Flood County Park Landscape Plan

Final Revised Environmental Impact Report/
Response to Comments Document

October 2019

Figure 5 Proposed Parking Map

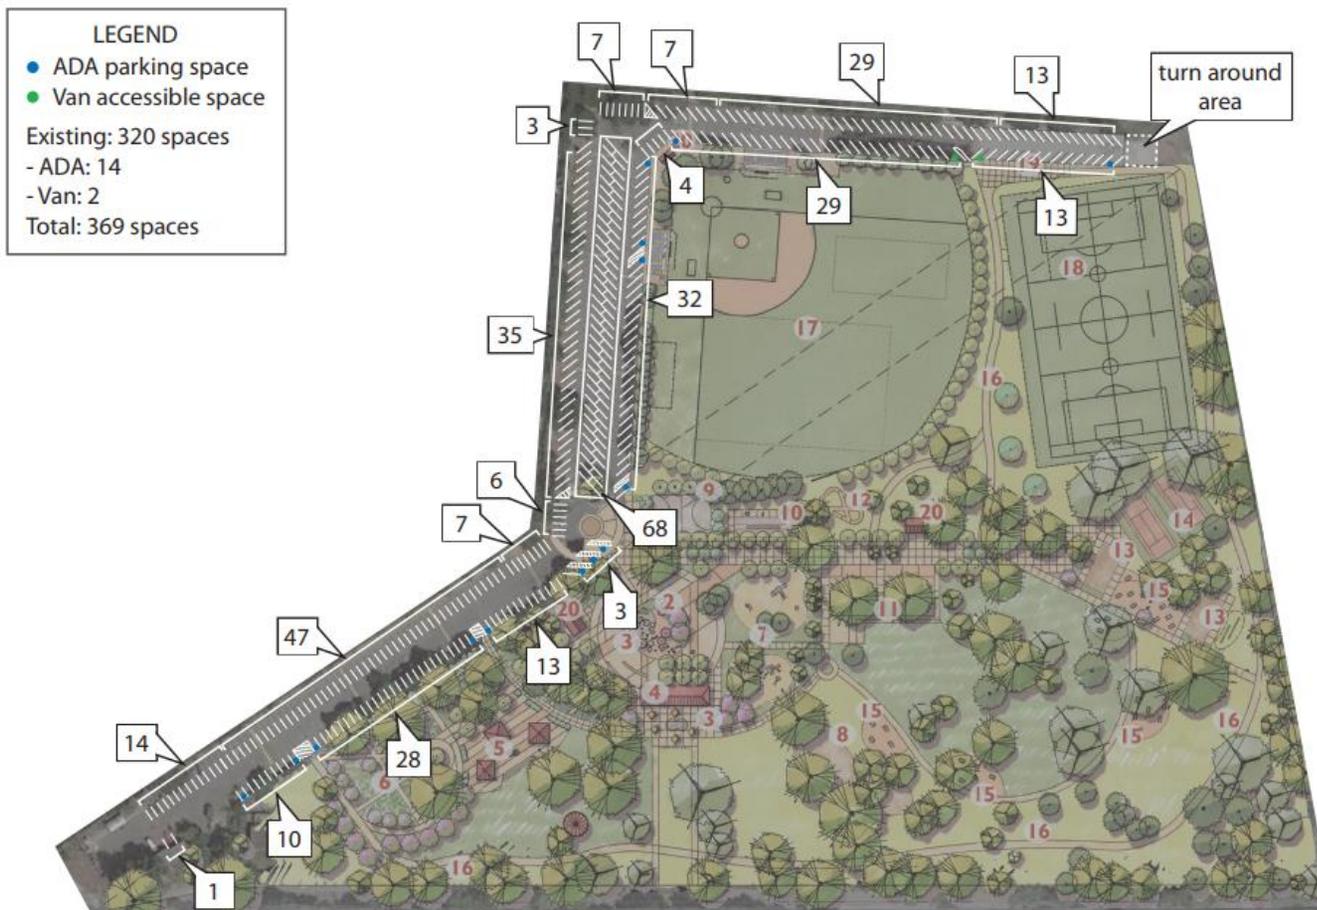
- *The Draft EIR's analysis of parking demand generated by the Landscape Plan is inadequate because it relies on inappropriate data and does not account for peak use of the park.*

A second parking count was completed at Flood Park on October 2, 2019 to confirm the number of parking spaces at Flood Park. The revised count identified a total of 320 existing parking spaces at Flood Park. As discussed on page 120 of the Draft Revised EIR the anticipated maximum parking demand during peak summer days under the Landscape Plan is 344 parking spaces. Therefore, there would be a deficient of 24 parking spaces. To account for the deficient in parking spaces the Landscape Plan has been revised to include additional 49 parking spaces at Flood Park. With the additional 49 parking spaces there would be a total of 369 parking spaces at Flood Park, which would exceed the peak parking demand by 25 parking spaces. The Final Revised EIR has been updated to include the following:

The Landscape Plan would not involve changes to parking and access, except for a new drop-off area on-site and stripping for an addition of 49 parking spaces on already paved and gravel surfaces. Flood County Park's existing vehicular access from Bay Road, via the entrance gate at the southwest corner of the park, would be retained, as would the existing asphalt parking lot on the western edge of the site. Pedestrians also would retain access to the park through entrances gaps in a chain-link fence along Bay Road and at the eastern gate from Iris Lane. An additional 26 parking spaces and a turnaround area would be added to the site of the existing pétanque court, as shown in Figure 4 and Figure 5, Proposed Parking Map. New parking stall locations have been identified throughout the site in existing paved areas and include the following: one parking stall near the existing pay station; two parking stalls in the island near the eastward turn near the ballfield; one stall in the island behind the ranger residence; one stall in the island on the south side of the eastward turn; seven stalls in the approximately 60 foot space and four stalls in the approximately 36 foot space before the pétanque court; and seven stalls by converting ADA van parking stalls to ADA car parking stalls . Therefore, an additional 23 stalls stripped outside of the pétanque court and 26 stalls stripped within the pétanque court would add a total of 49 new parking spaces at Flood Park. Please see Figure 5 for a layout of all 369 parking spaces.

Figure 5 Proposed Parking Map

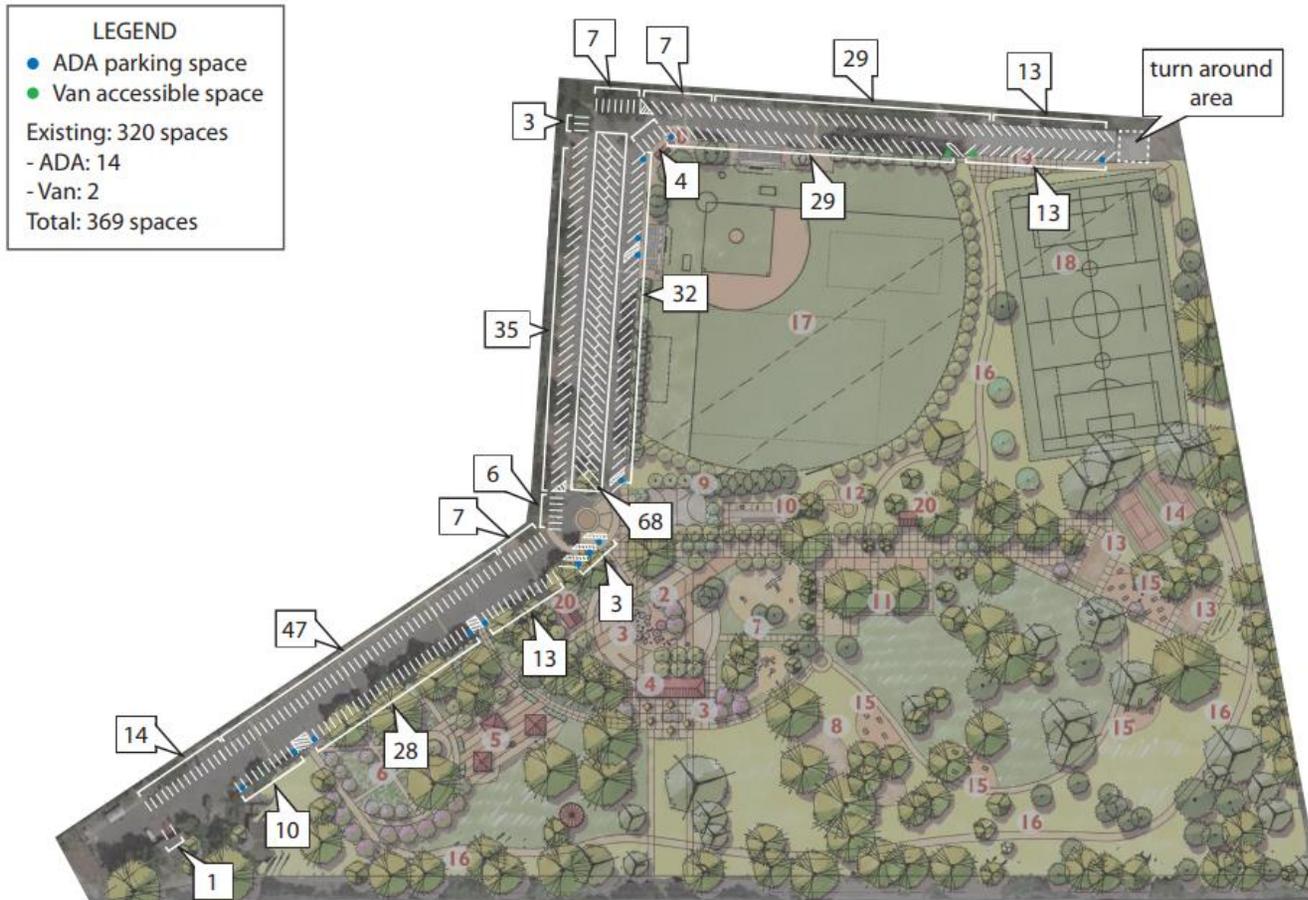
The EIR states there are 375 parking spaces. This is not correct. There are 330 spaces. Please confirm this count.

Plan. However, during an October 2019 count it was determined that there is a total of 320 parking spaces at Flood County Park. As discussed above, user capacity is appropriate to determine parking demand for the proposed project.

The anticipated typical peak parking demand for the proposed project is 344 parking spaces. The project would add an additional 49 parking spaces at the park for a total of 369 parking spaces. Available parking would exceed the projected demand of 344 parking spaces by 25 parking spaces. Therefore, the on-site parking lot would have sufficient capacity to accommodate parking demand except on rare occasions, such as very large scheduled events. In addition, Mitigation Measure T-6 would inform park visitors of on-street parking restrictions, require the County to coordinate with the City of Menlo Park to reduce parking in adjacent neighborhoods, and encourage targeted enforcement of on-street parking.
